Access Compliance Report

Public Rights-of-Way

Intersection ID: 54193	Main Street: SYCAMORE CENTRE DR	Cross Street: TYVOLA CENTRE DR	Location: NW
ADA ID: F91E98CC9CB1	Ramp Type: BlendTrans1	Initial Pass/Fail: Pass	Overall Compliance: No
		Severity Score: 0

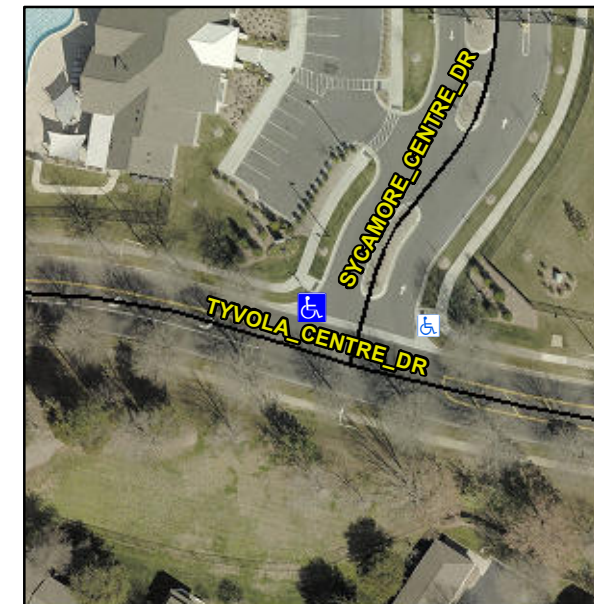
Not Found, R304.2.2-Perp, R304.3.2-Para, R305.2

N/A	Ramp inside XWalk1?	N/A	N/A	Ramp inside XWalk2?	N/A
	Road Slope (%)	0.6		Clear Space?	Yes
	Road X Slope (%)	5.8	N/A	Clear Space to XWalk (in)	N/A
Yes	Any Obstructions?	No	Yes	Storm Grate/Utility Hazard?	No
	Obstruction Type			Storm Grate/Utility Type	
		N/A			N/A
			Yes	Surface Condition? (G/P)	Good
			No	Curb Slope (%)	6.1

Remove & Replace Curb Ramp With Two New Directional Ramps or Equivalent.
